Re: 604 Endicott St N, Laconia Site Plan

I have reviewed the revised Site Plan and Stormwater Management Analysis Report for 604 Endicott St N, known as Tiki Plaza. The revision date listed on these documents is January 13, 2025.

Letter to Bob Heavey
604 Endicott St N – Stormwater Comments - Revision
June 20, 2025

Figure 1: Route 3 Flow

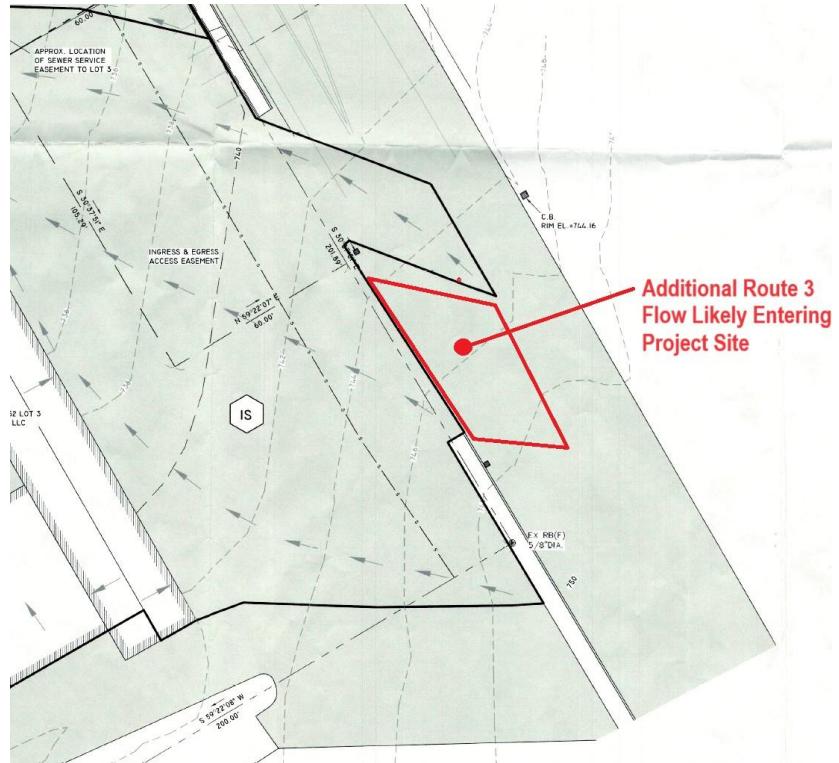
1. As stated previously, the hydrologic model appears to underestimate the area of Route 3 flowing onto 604 Endicott St N. No additional area was added to the revised stormwater calculations to account for this flow from Route 3. The existing and proposed flows onto 554 Endicott St N are likely slightly underestimated by the model. See Figure 1 and Figure 2 on the following page:

Figure 3: Rear Gravel (Existing Conditions Plan)

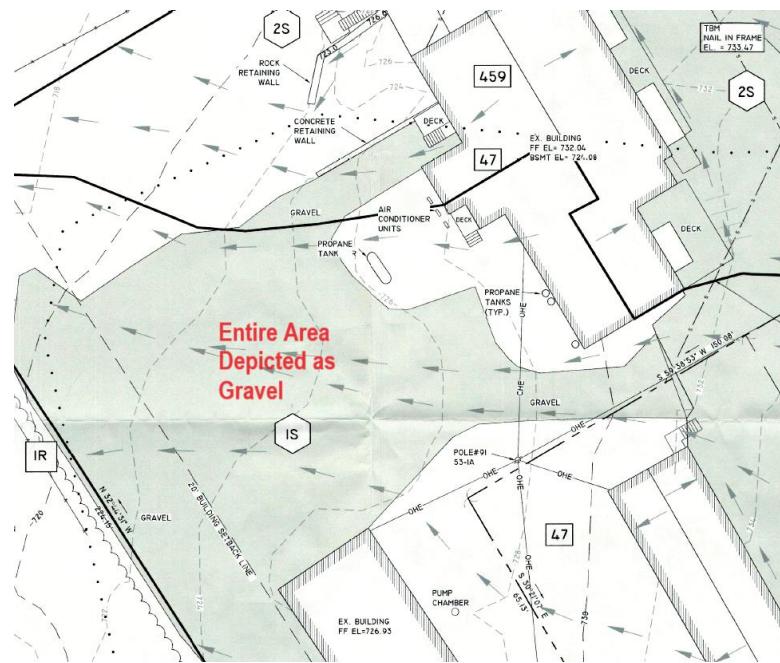
2. As stated previously, the Pre-Condition map depicts approximately 4,000 sq ft of existing gravel area that is not depicted on the Existing Conditions plan. This area was not added to the pre-development drainage model. If this gravel area does not exist then the model likely calculates the existing flows to be higher than they actually are. This, in turn, may result in proposed flows that are higher than the actual existing flows.
